UNITED STATES PATENT AND TRADEMARK OFFICE

Office Action Summary

10/028,305

DETAILED ACTION

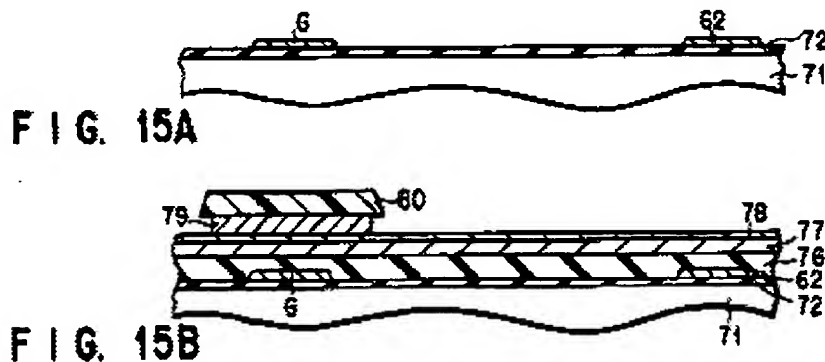
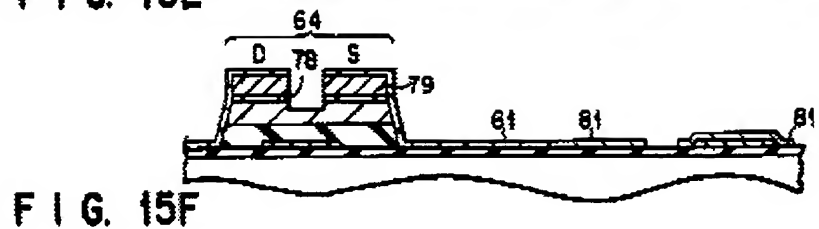
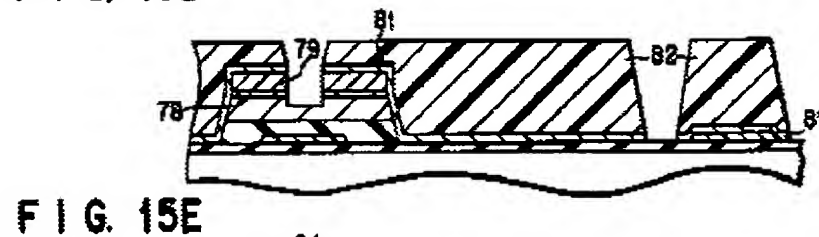
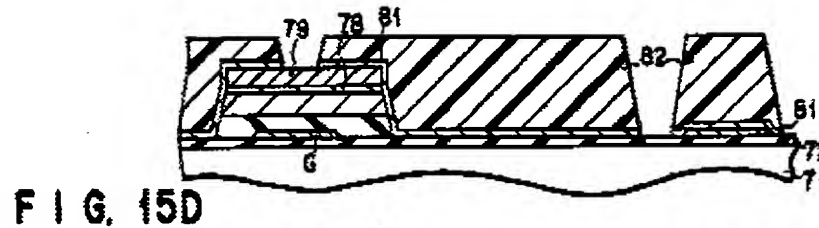
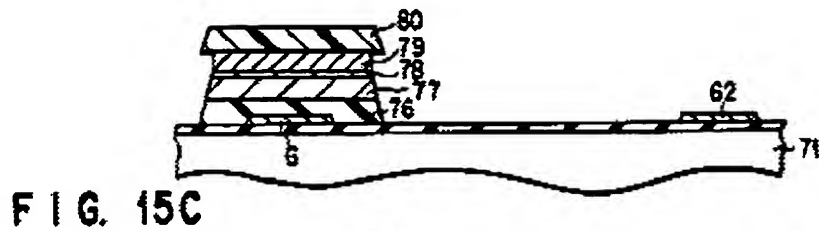
Claims 1, 8, and 21 are rejected under 35 U.S.C. 102(b) as being anticipated by Ueda et al (Ueda) USPAT 6,078,365.

As to claim 1, Ueda discloses an embodiment in Figures 15A-15F (col. 12, line 58, through col. 18, line 33, especially col. 16, line 64, through col. 18, line 33) comprising: a substrate, 71; a gate electrode, G, over the substrate; a first semiconductor layer, 77, over the gate electrode; a second semiconductor layer, 78, over the first semiconductor layer and having a defined outer edge, source, S, and drain, D, electrodes (Applicant's first metal layer) on the second semiconductor layer, the first metal layer patterned in a same pattern as the second semiconductor layer such that the first metal layer and second semiconductor layer define the channel (Applicant's separation region). Please note that this is by way of only one photolithography pattern per Figures (Applicant's patterned in the same pattern).

Ueda further discloses the use of source, S, and drain, D, comprised of Aluminum and Molybdenum disposed on Molybdenum (Mo/Al/Mo) (comprises Applicant's electrodes over the first metal layer), the source and drain electrodes patterned the same as the first metal layer and having a defined outer edge and the

second semiconductor layer (col. 17, lines 22-42) define first upper portion of the separation region, and the source and drain electrodes include a second (Al) and a third (Mo) metal layer, in order to use a low resistance metal such as Aluminum for improved conductivity of the circuit components (col. 17, line 55, through col. 18, line 5).

The outer defined edges of the metal layers and silicon layers are all lined up and abut each other to define the channel as illustrated.
